TITLE: PUBLIC HEARING on a Small Subdivision Permit and Plat for Robb's Roost, located in a portion of land situated in the SE ¼ of Section 24, T15N, R65W, of the 6th P.M., Laramie County, WY.

PZ-26-00041

ROBB'S ROOST SMALL
SUBDIVISION PERMIT AND PLAT

FINAL PLAT OF ROBB'S ROOST

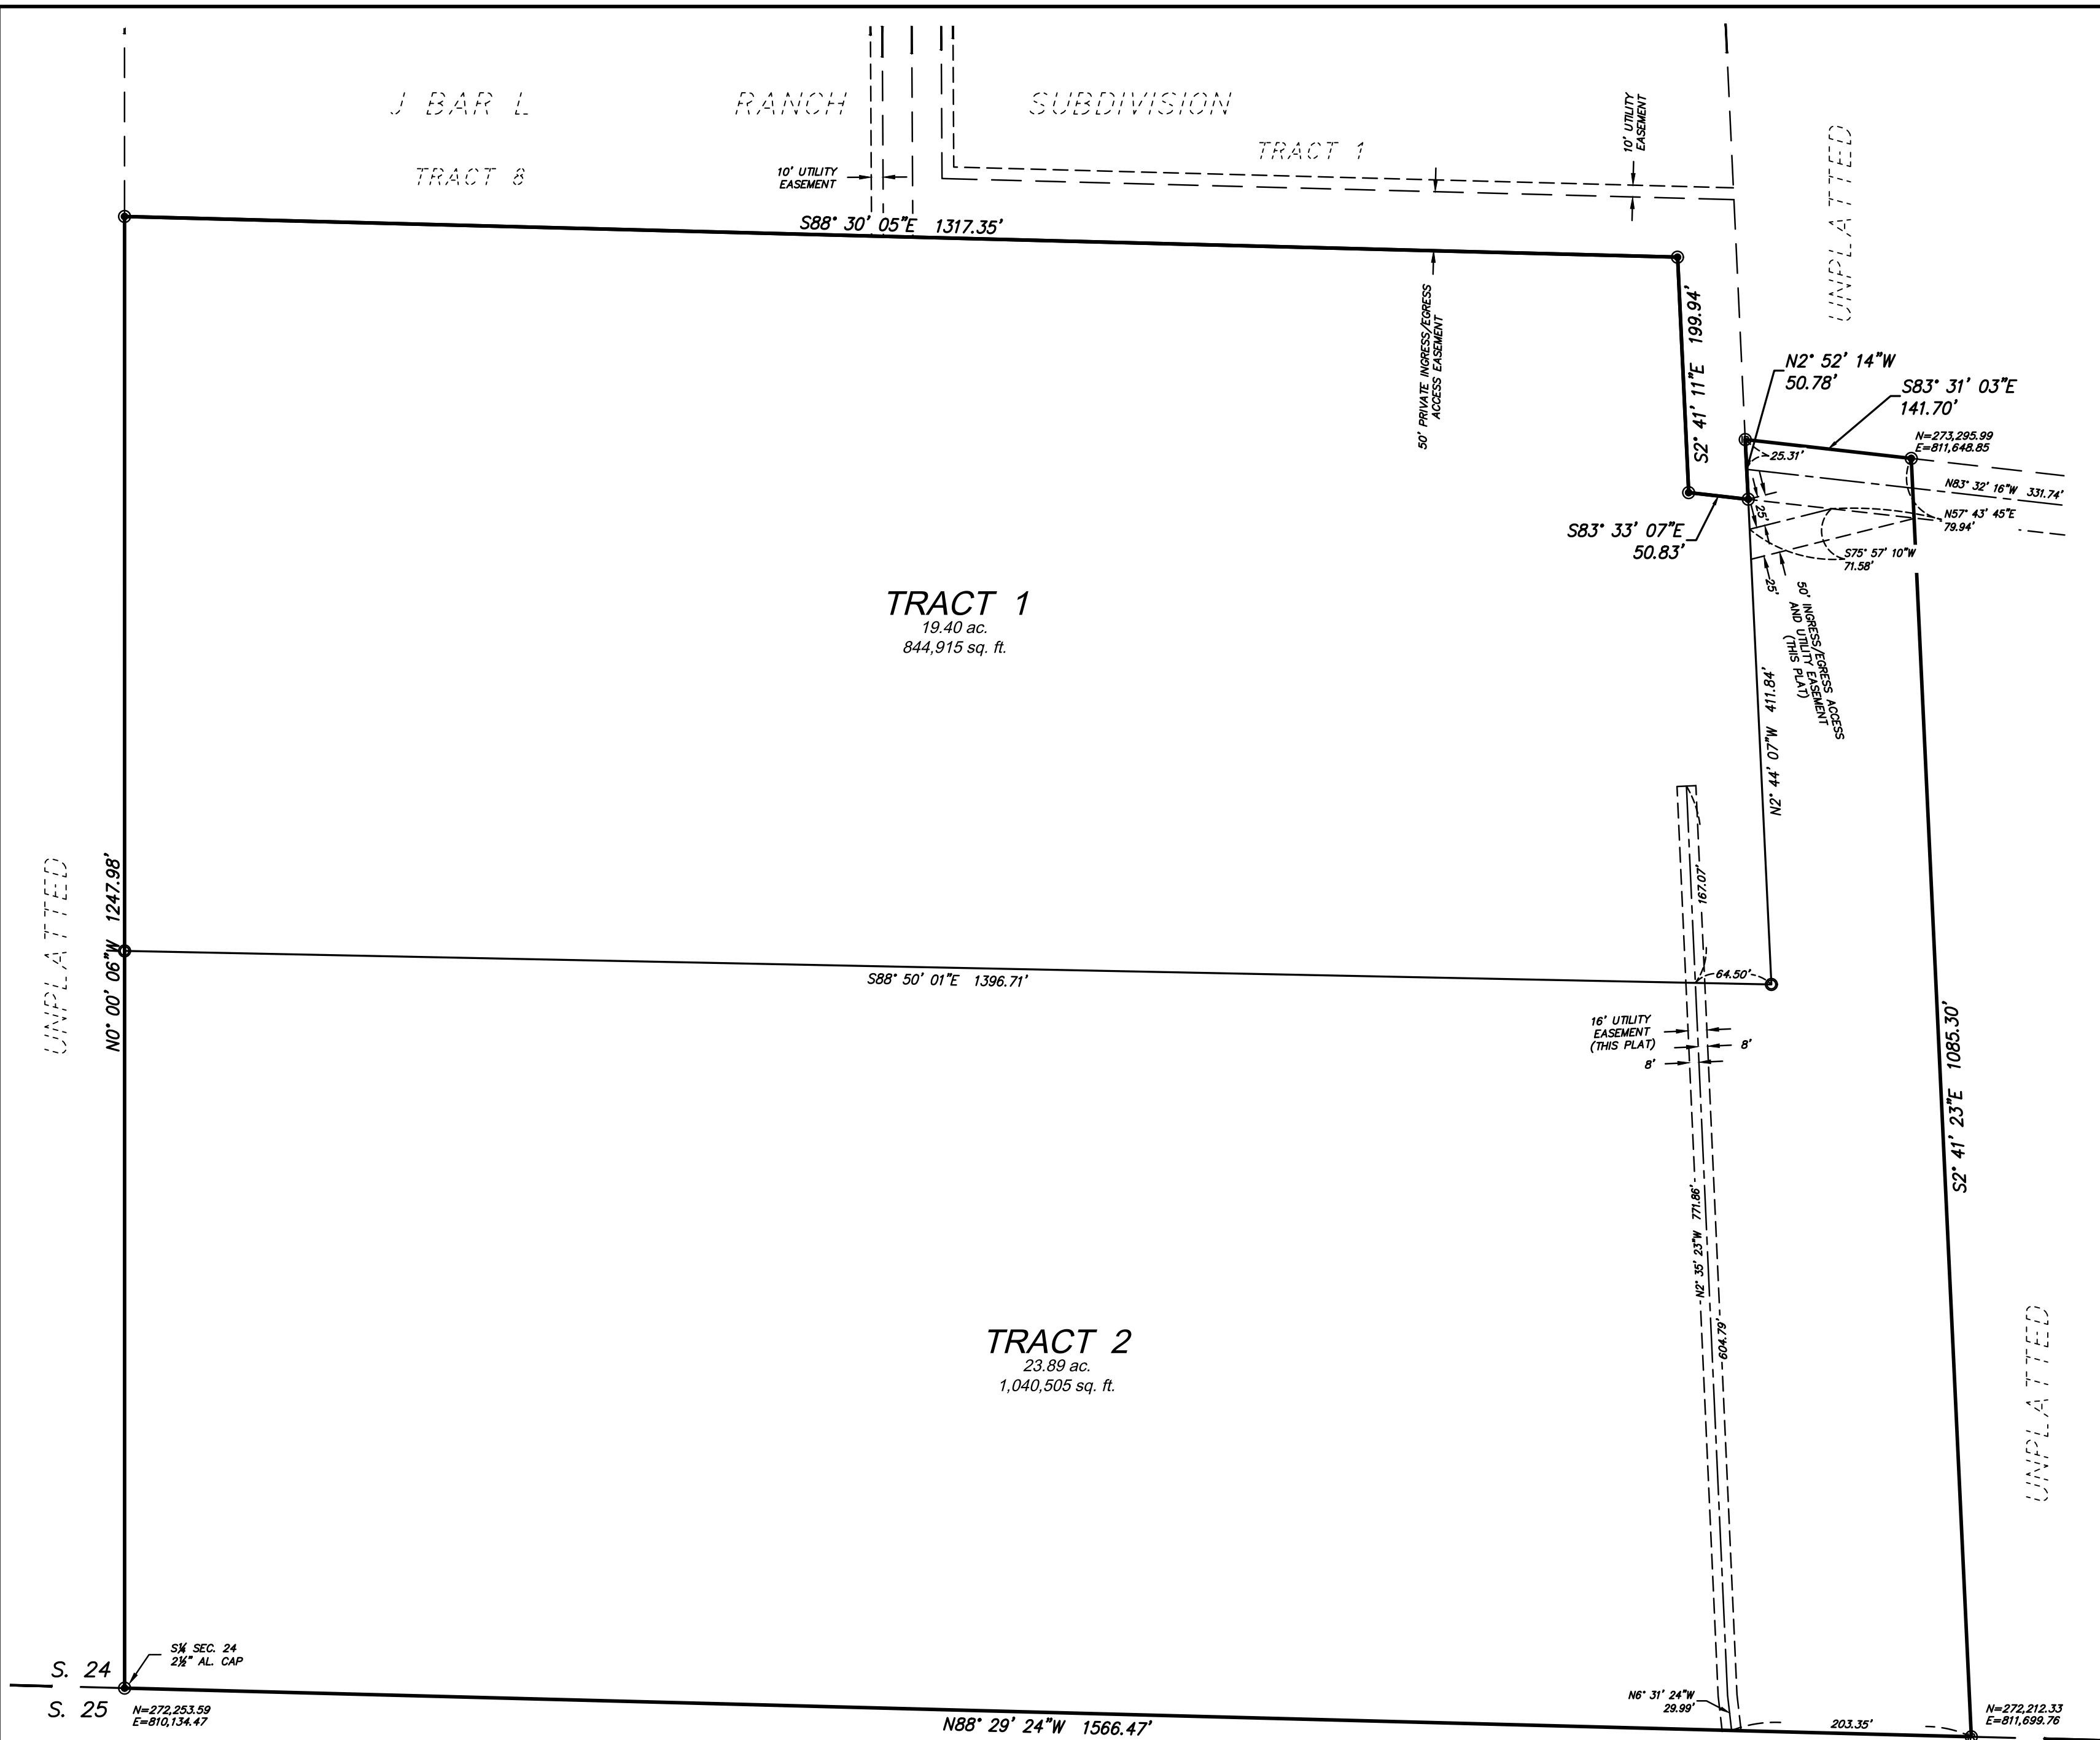
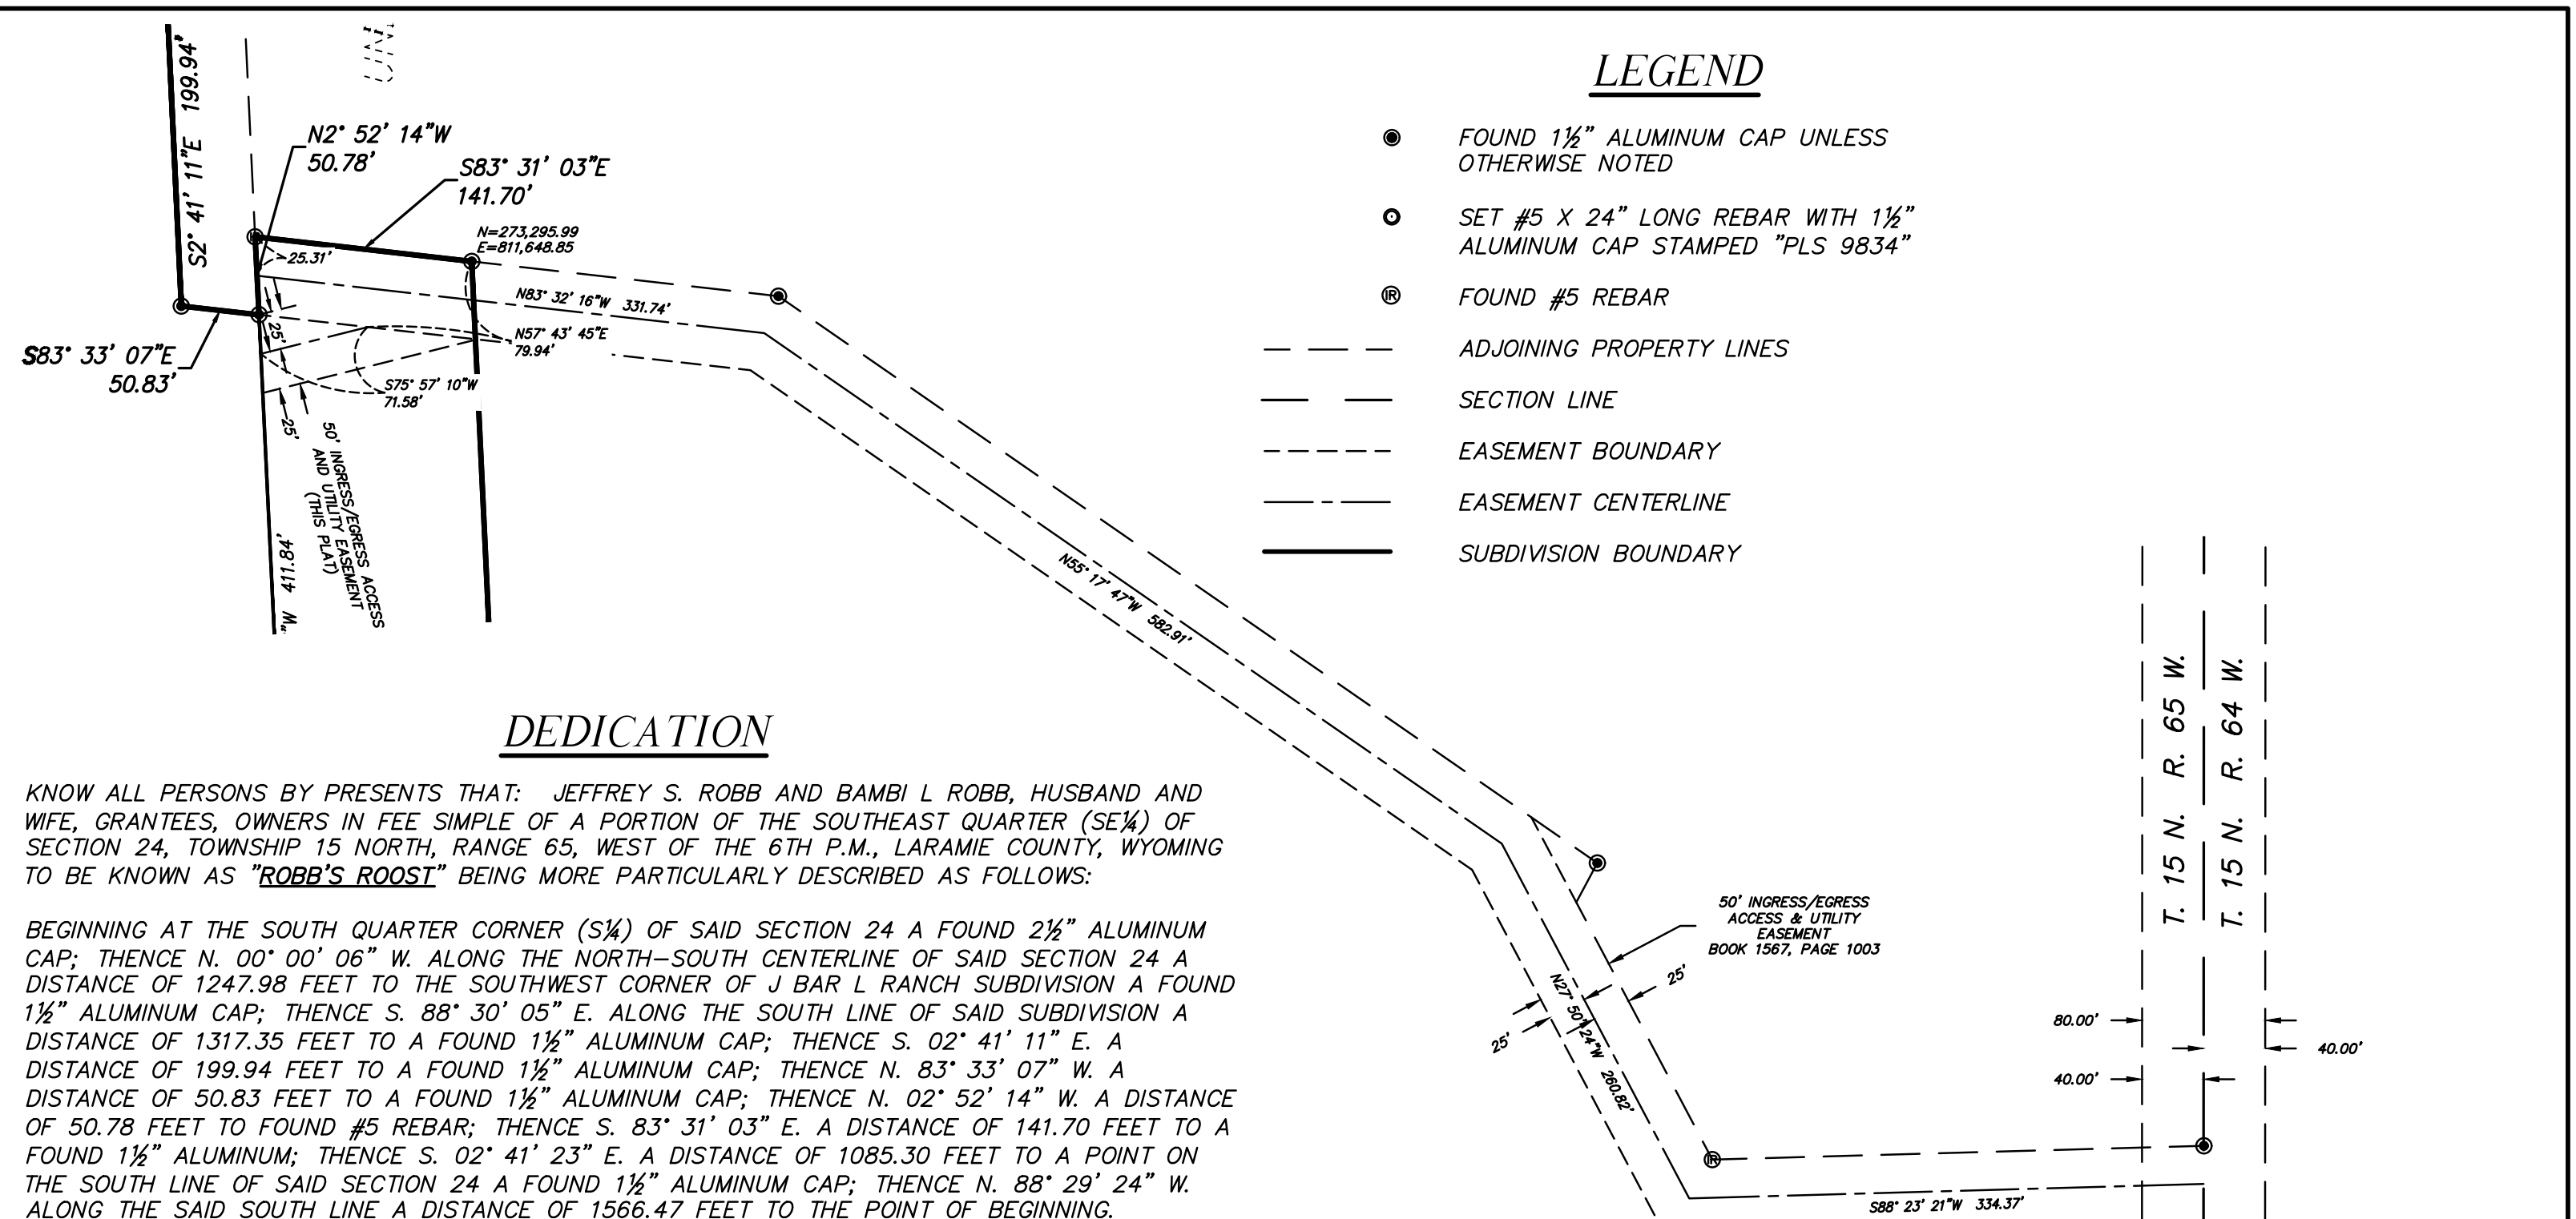
1. There are some minor differences in bearings and distances between the plat and the deed provided that are not shown on the plat.
2. The 50' INGRESS/EGRESS ACCESS & UTILITY EASEMENT (BOOK 1567, PAGE 1003) described in the AFFIDAVIT GRANT OF ACCESS & UTILITY EASEMENT (BOOK 1567, PAGE 1003), included in the Warranty Deed (BOOK 1624, PAGE 849) and shown on this Final Plat of ROBBS ROOST, does not note to whom the 50' INGRESS/EGRESS ACCESS & UTILITY EASEMENT is granted.

Easement (this plat) partially overlaps the existing 50' Ingress/Egress access and utility easement. Does the new easement only need to be the portion that does not overlap so there are not two access and utility easements on top of each other?
 5. Although the Transportation Assessment Worksheet is filled out incorrectly, this subdivision does not meet the criteria for a Traffic Impact Study.
 6. Per the regulations, this subdivision does not meet the criteria for a Preliminary Drainage Report so a waiver request is not needed.

Surveyor Comments:
 1. There are some minor differences in bearings and distances between the plat and the deed provided that are not shown on the plat.
 2. The 50' INGRESS/EGRESS ACCESS & UTILITY EASEMENT (BOOK 1567, PAGE 1003) described in the AFFIDAVIT GRANT OF ACCESS & UTILITY EASEMENT (BOOK 1567, PAGE 1003), included in the Warranty Deed (BOOK 1624, PAGE 849) and shown on this Final Plat of ROBBS ROOST, does not note to whom the 50' INGRESS/EGRESS ACCESS & UTILITY EASEMENT is granted.

06/02/2026	Workflow	ENGINEERS REVIEW	GENERAL	2nd Review Engineer Comments: 1. Section 4-5-102 of the Regulations requires the Legend to contain and define all various symbols, line types, shading/hatching, etc used in the drawing. The Legend does not include the easement line types, property line types, platted boundary line types, centerline line types, Section lines, etc. that are shown on the plat drawing.	SCOTT.LARSON@LARAMIECOUNTY WY.GOV
06/03/2026	Workflow	PLANNING AND ZONING REVIEW	GENERAL	All plat corrections have been made and comments acknowledged or corrected. Nothing further.	SONNY.HOOPS@LARAMIECOUNTY WY.GOV

The easement document does not indicate grantee. It is believed that it was created to reach the properties owned by Robb and J Bar L Ranch Subdivision
